ADDENDUM #2

Reference: Losee Center Remodel
Utah Valley University – Orem, Utah
DFCM Project No. 07196790

ADDENDUM - 2

Project: UVU Losee Center Remodel
DFCM Project Number: 07196790
Axis Project Number: 0719
To: Mike Ambre
From: Axis Architects
Date: August 20, 2008

D6 CLERESTORY DETAIL

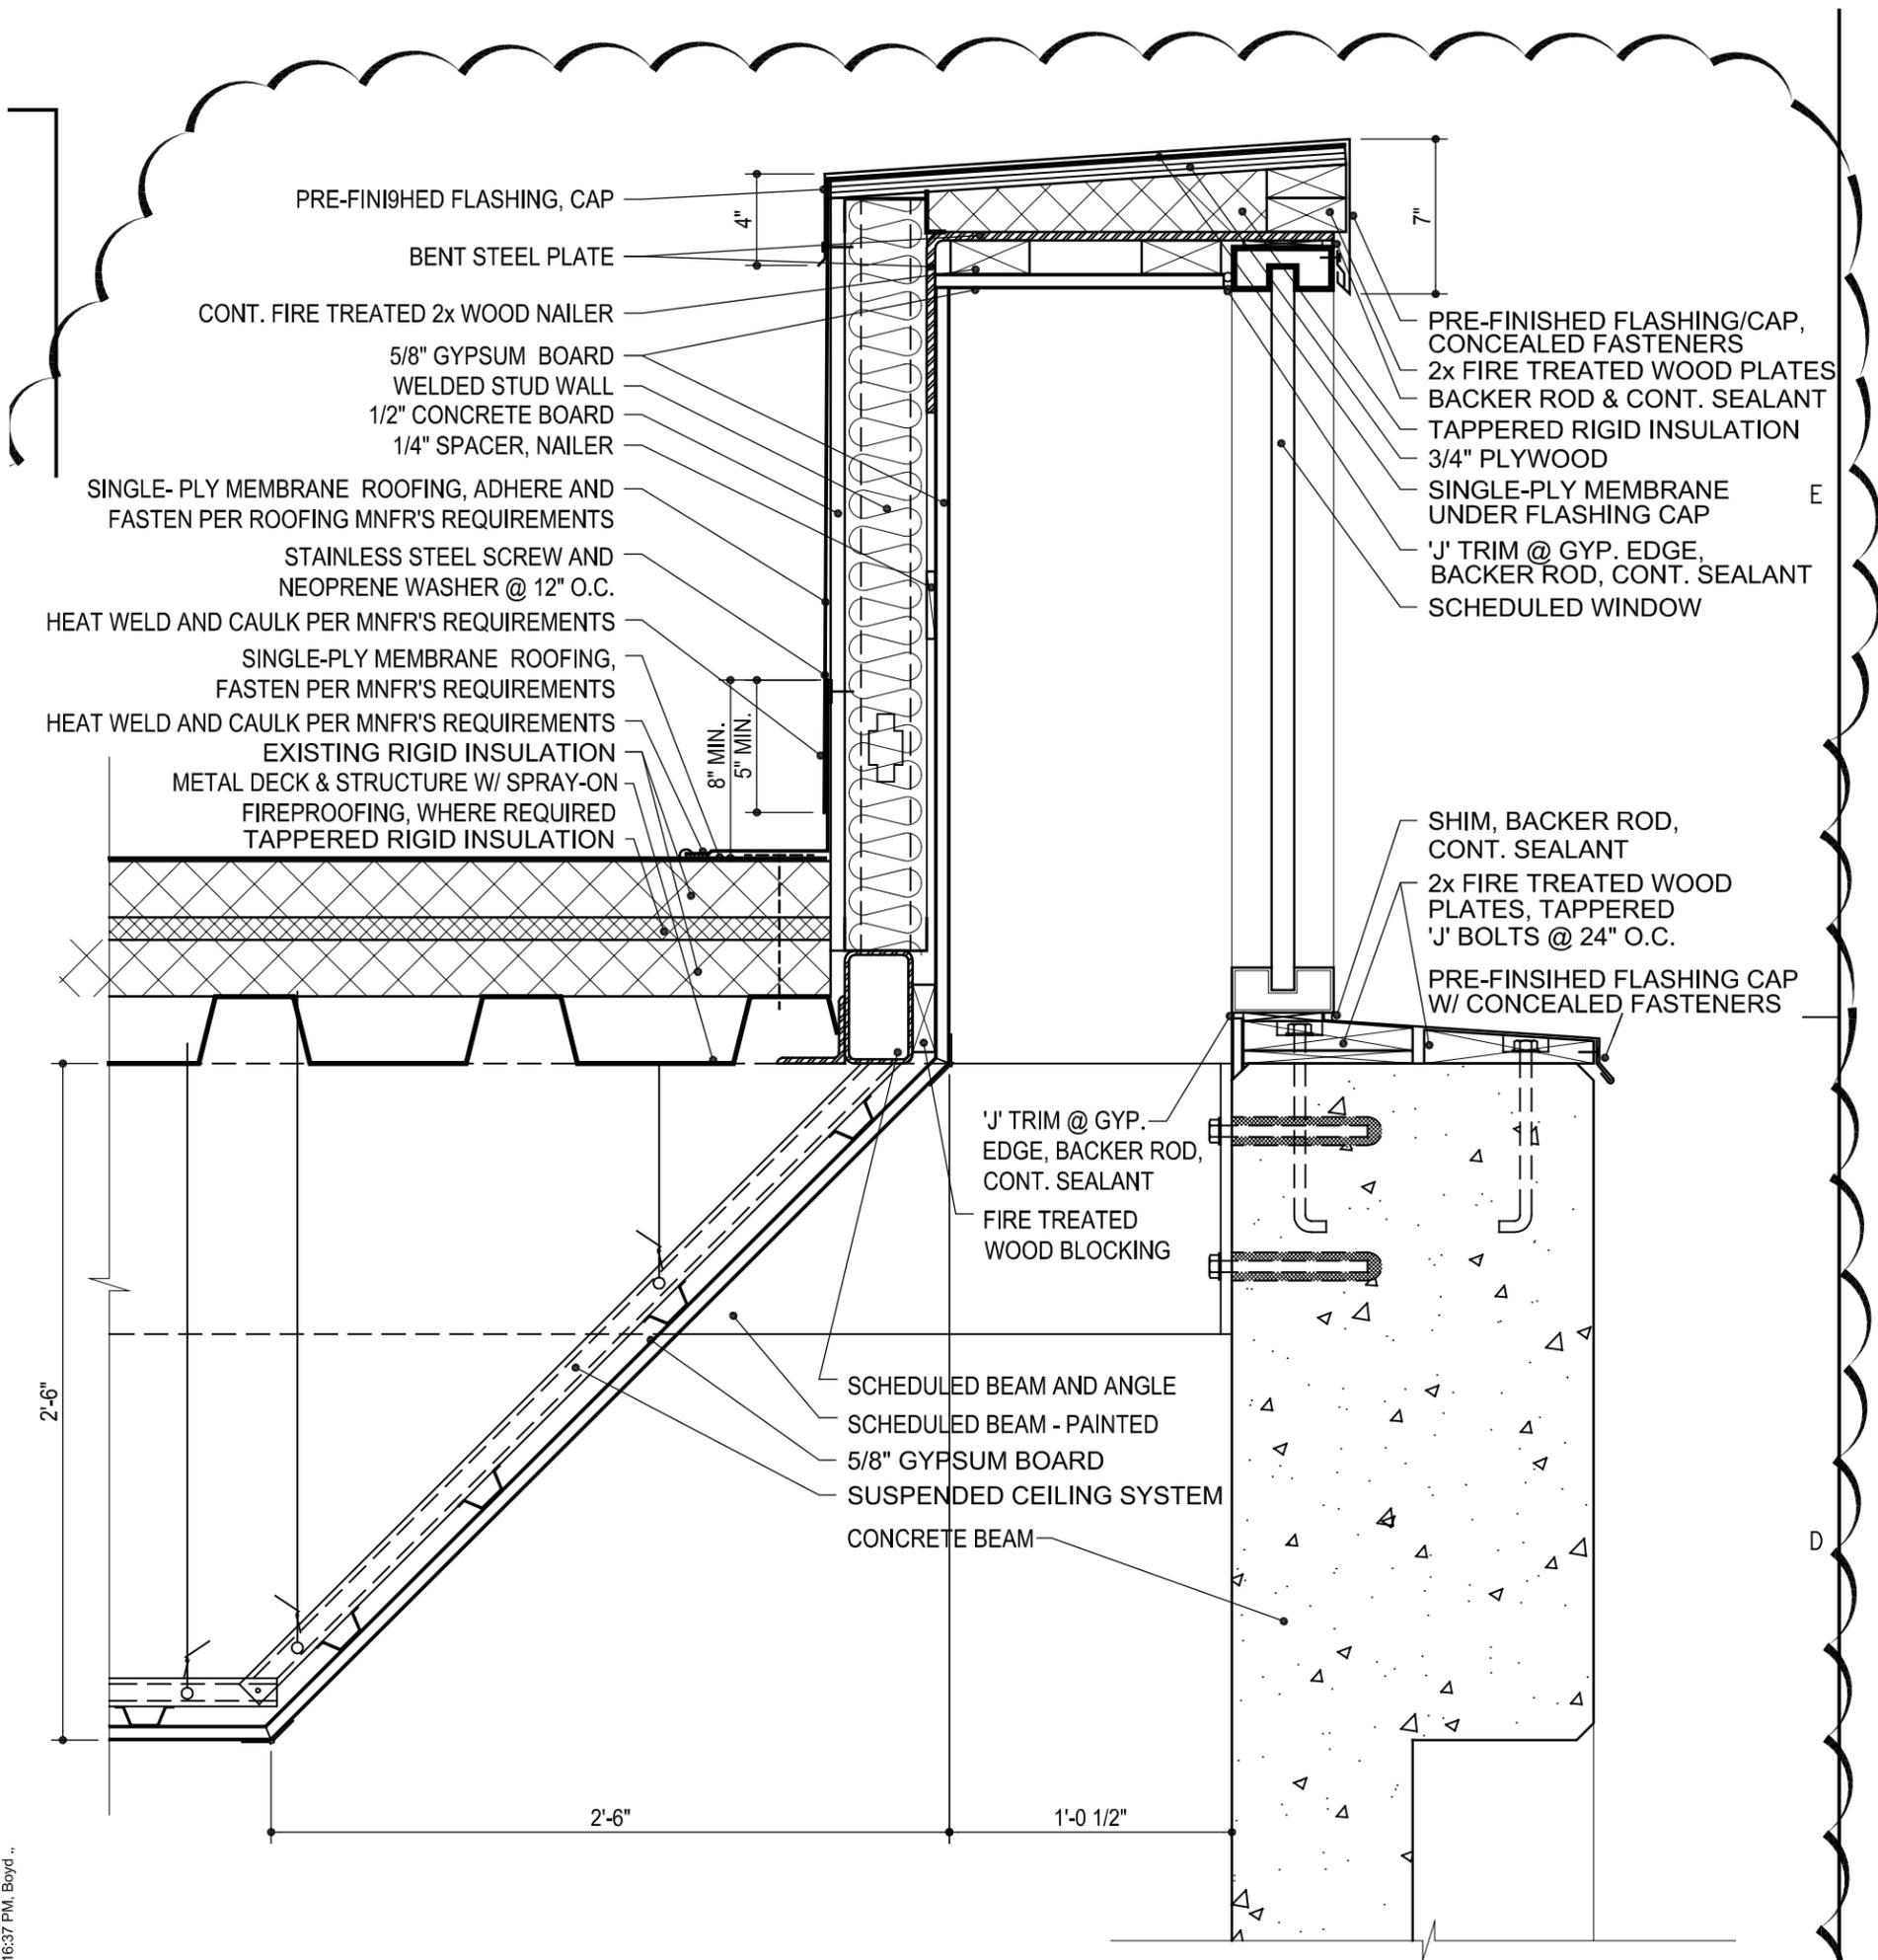
Provide a 2 hour shaft enclosure at elevator in accordance with UL Design No. V449 (3 layers of gypsum board at inside, metal studs and 1 layer of gypsum board at outside). See Specifications for Through-Penetration Firestop Systems.
- AE401
- Change the scale indicated for Details A2, A3, A4, A5 and A6 to be 3"=1'-0".
 - Remove Detail Markers D4 and D6.
- AE502
- Add revised portion of Detail1A/AE502 as shown on the attached ADD 2.04.
- AE503:
- Remove the previously issued Drawing AE503 and replace it with the attached revised Drawing AE503.
- AE601
- Detail E1/AE601 – change reference to Detail CL-02 to read E2/AE601.
 - Add Detail B5/AE601 as shown on the attached ADD 2.05.
 - Add Detail C6/AE601 as shown on the attached ADD 2.06.
 - Remove Detail Markers C5.

MODIFIED PORTION OF AE602 ADD 2.07

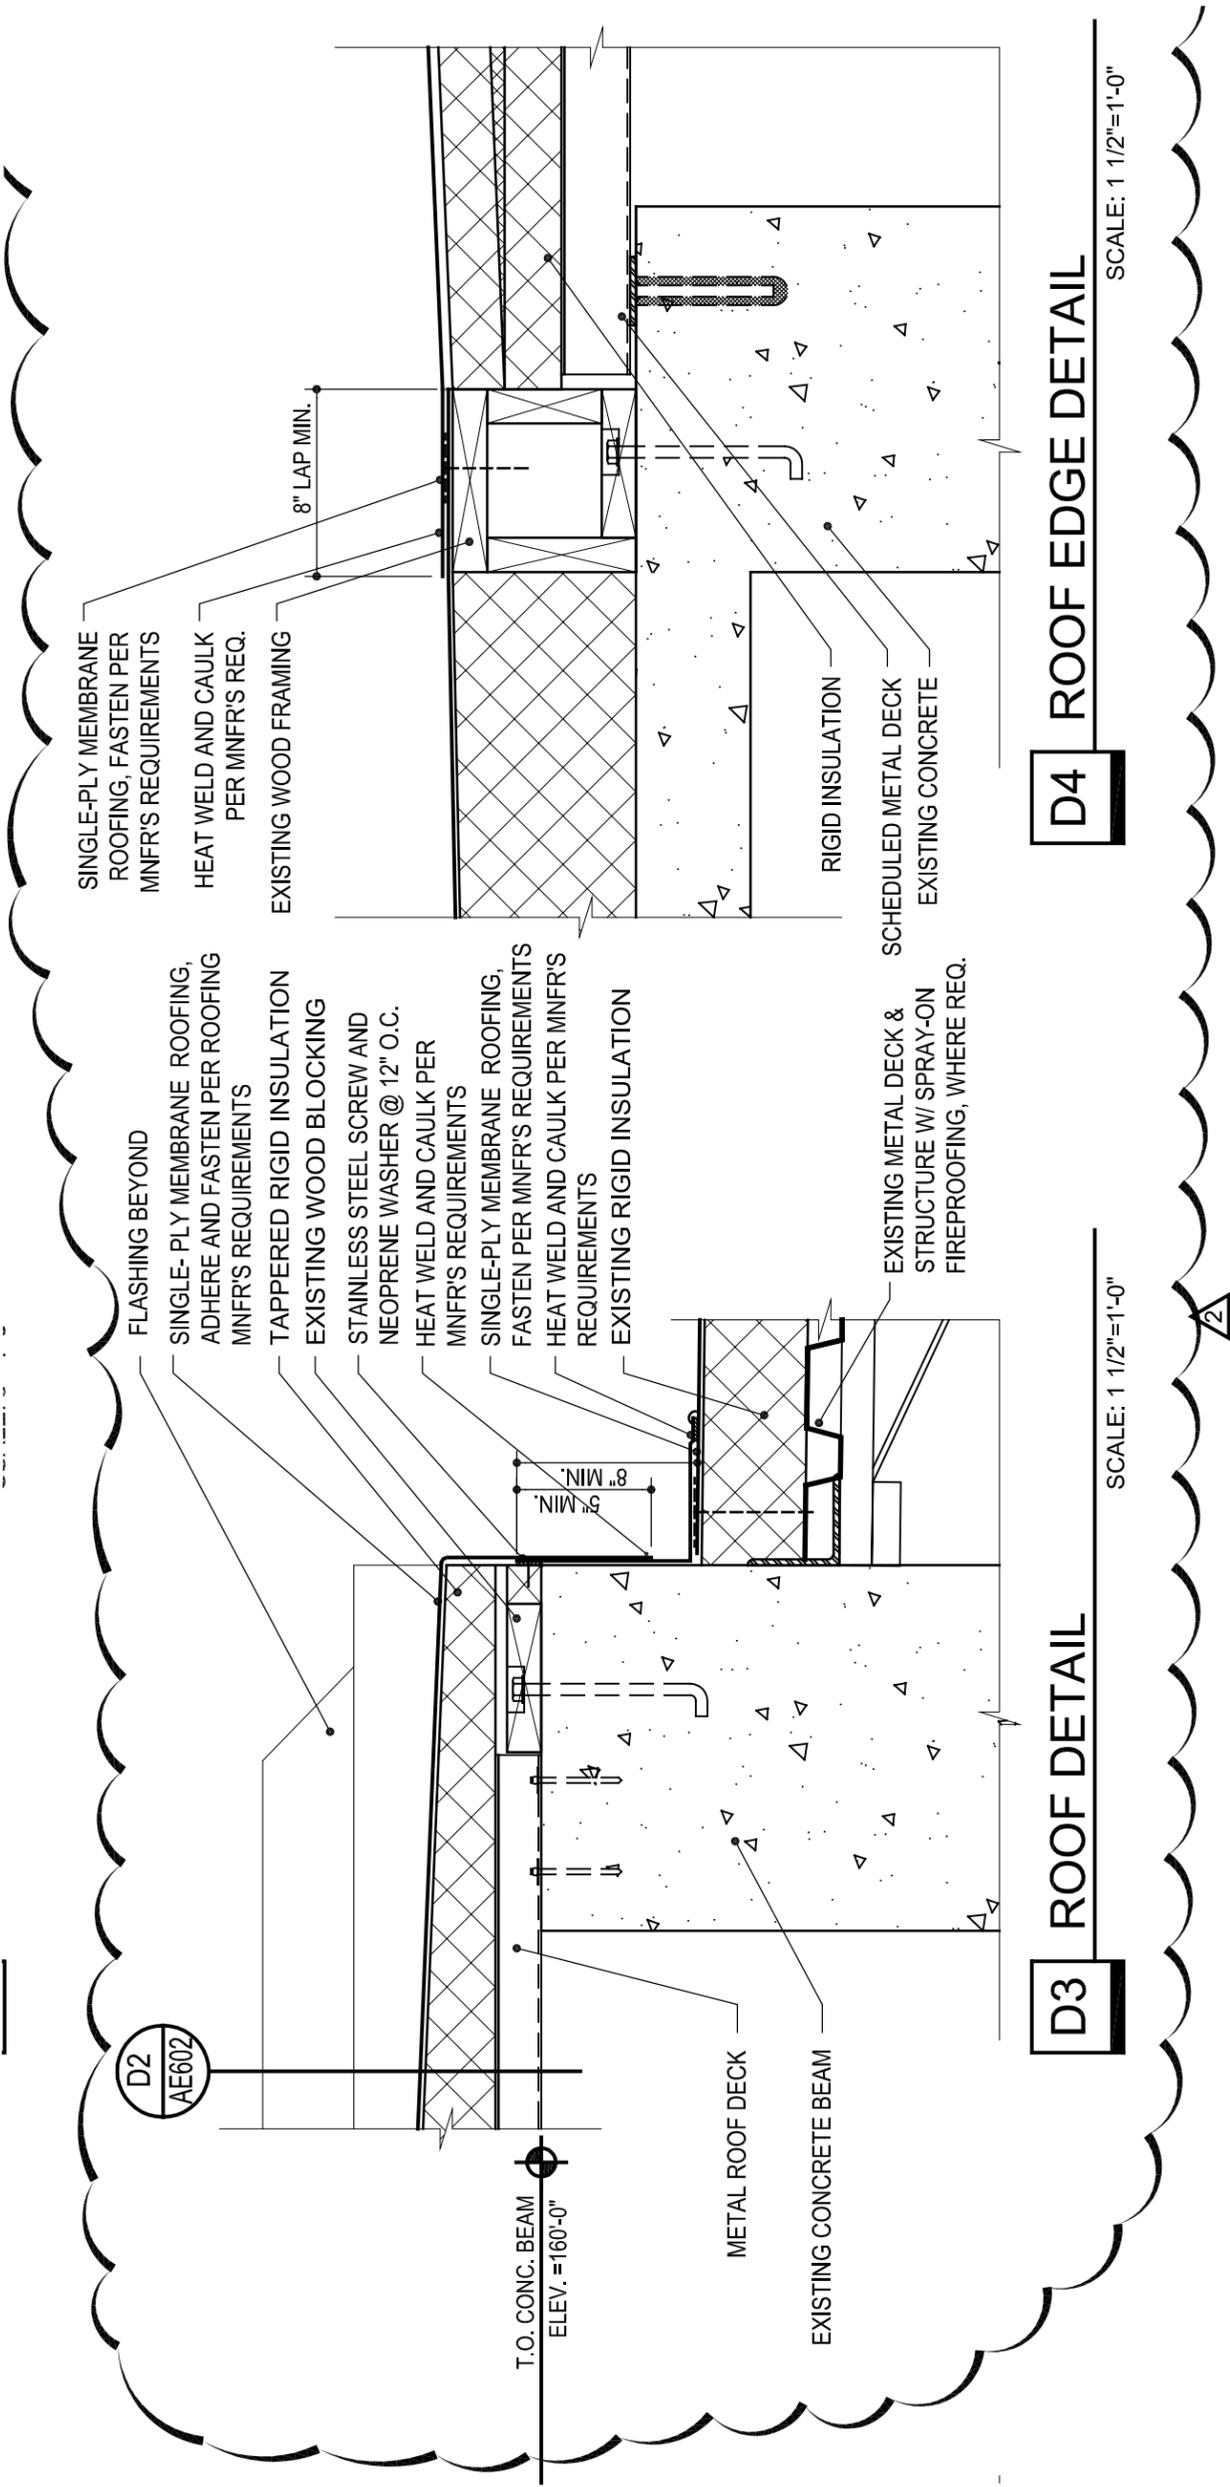
- AE602
- Replace the previously issued Detail D6/AE602 with the revised Detail D6AE602 as shown on the attached Drawing ADD 2.07. This revision increases the text size and indicates Fire Treated Blocking where wood blocking occurs

- Replace the previously issued Detail D3 & D4/AE602 with the revised Details 2AE602 as shown on the attached Drawing ADD 2.08.
 - Change the scale of Details D1, D2, B3, and B4/AE602 to 1 1/2"=1'-0".

MODIFIED PORTION OF AE604
ADD 2.09

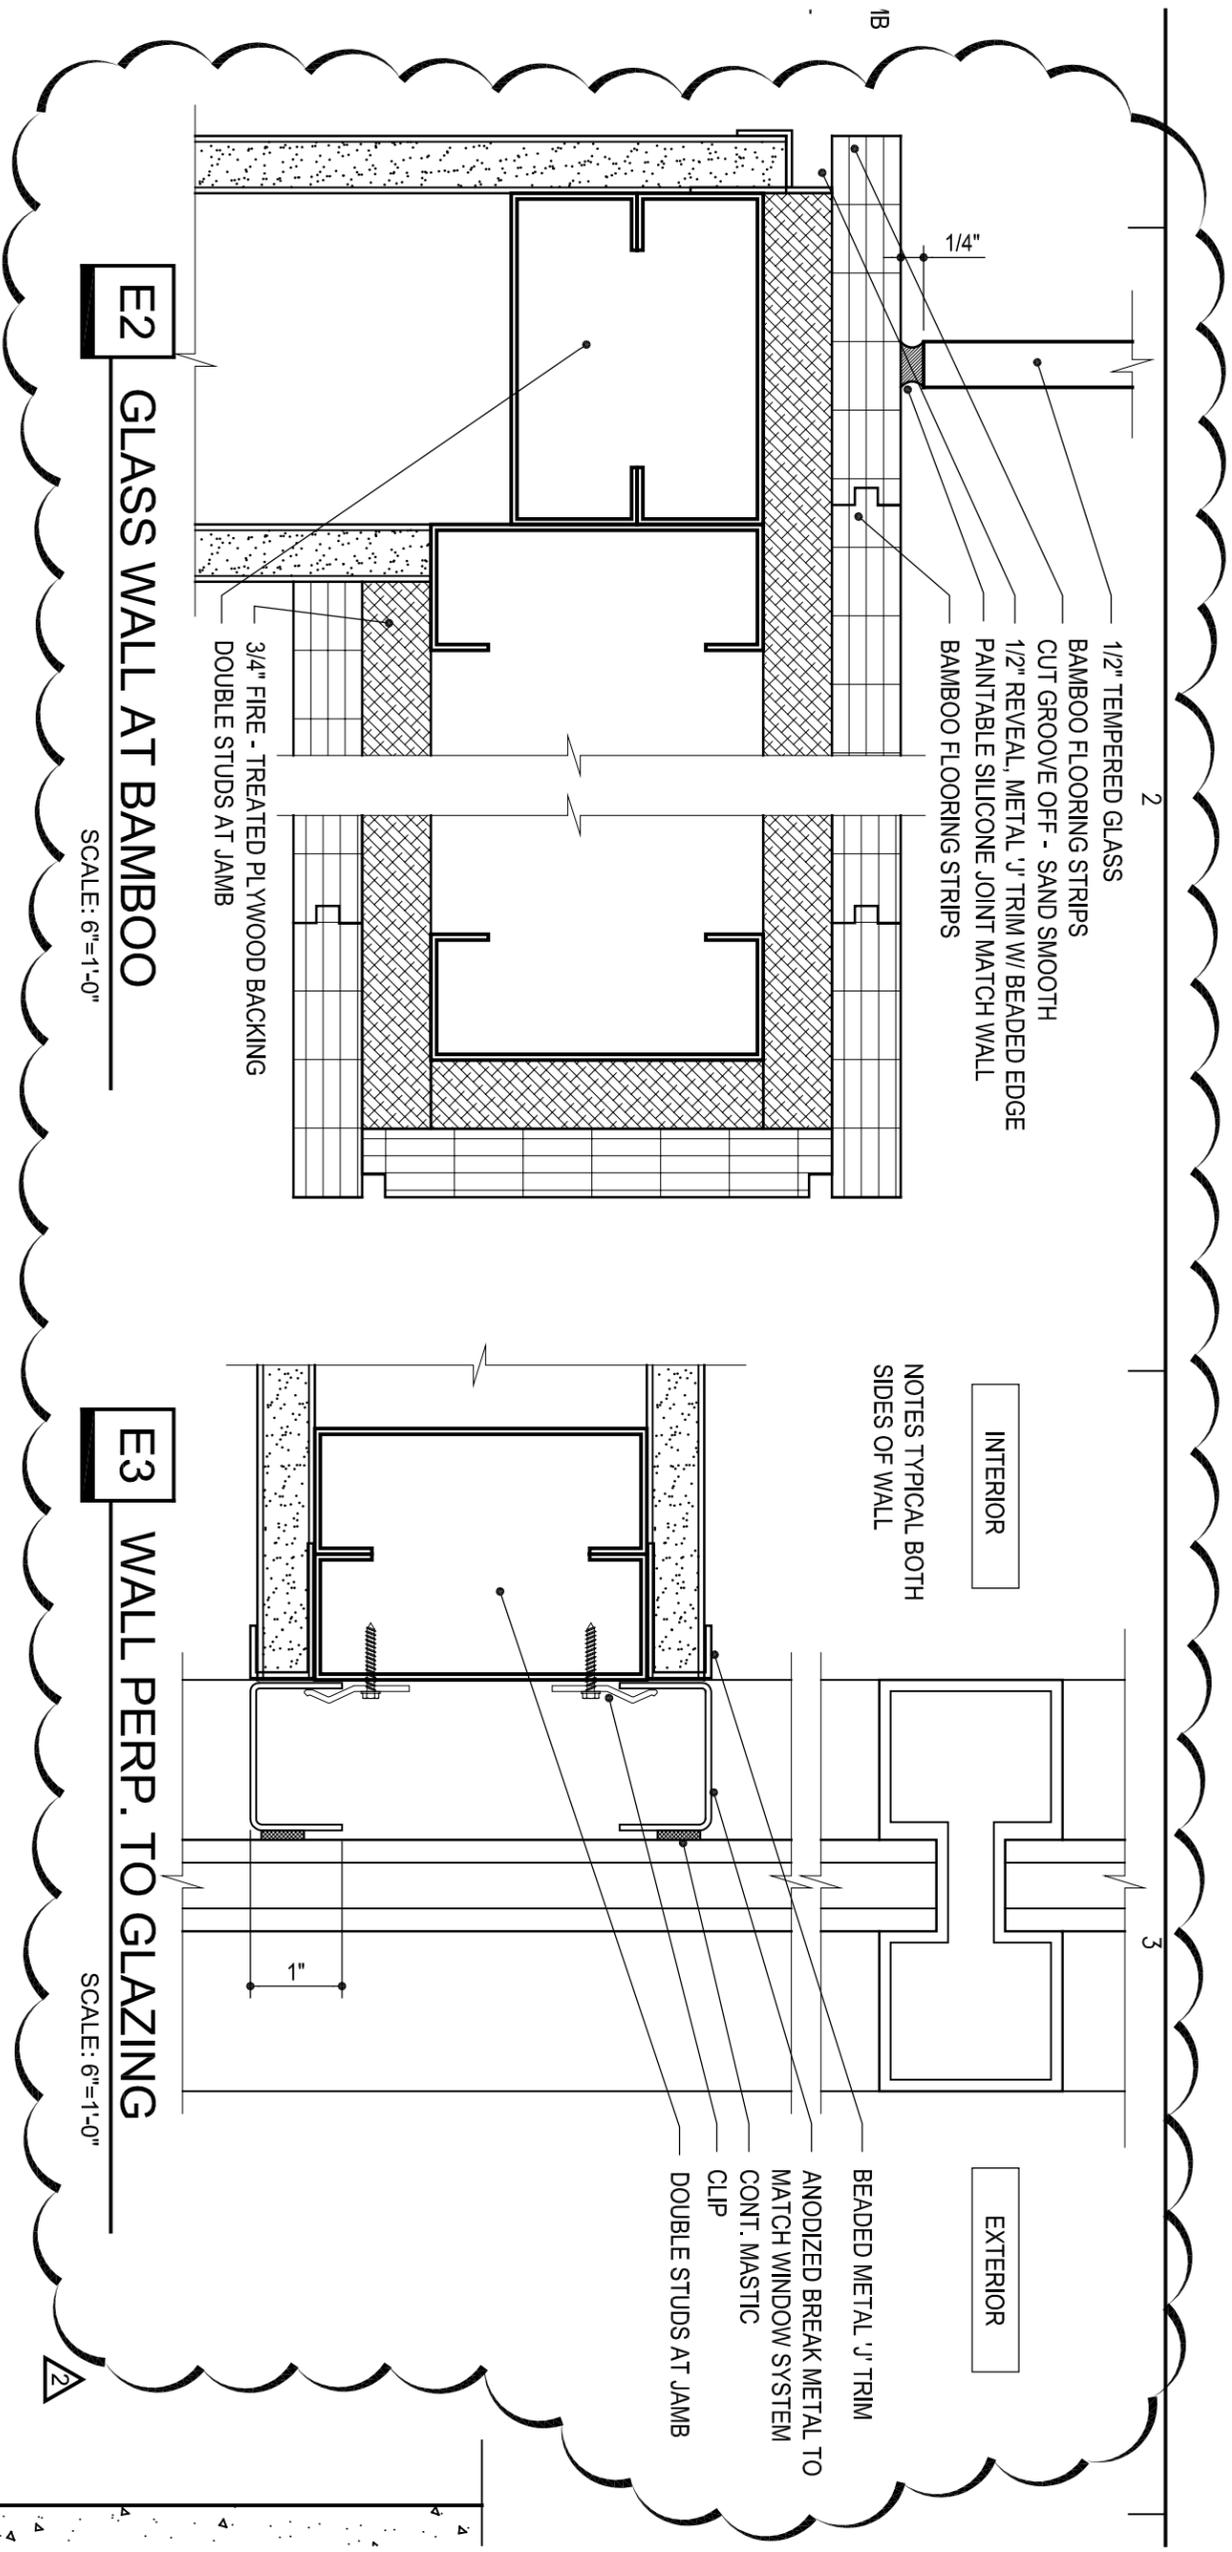
- AE604
- Add Details E2 and E3/AE604 as shown on the attached ADD 2.09.
 - Change the scale of Details A2, B1, B2, C1, C2 and E1/AE604 to 6"=1'-0".
 - Change the scale of Details A3, A4, A5, and A6/AE604 to 3"=1'-0".

- AE802
- Change the Detail Callout on the left edge of Frameless Glass System G7 to read E2/AE604.
 - Add a Detail Callout "C1/AE604 – Sim." To the right edge of Frameless Glass System G7.
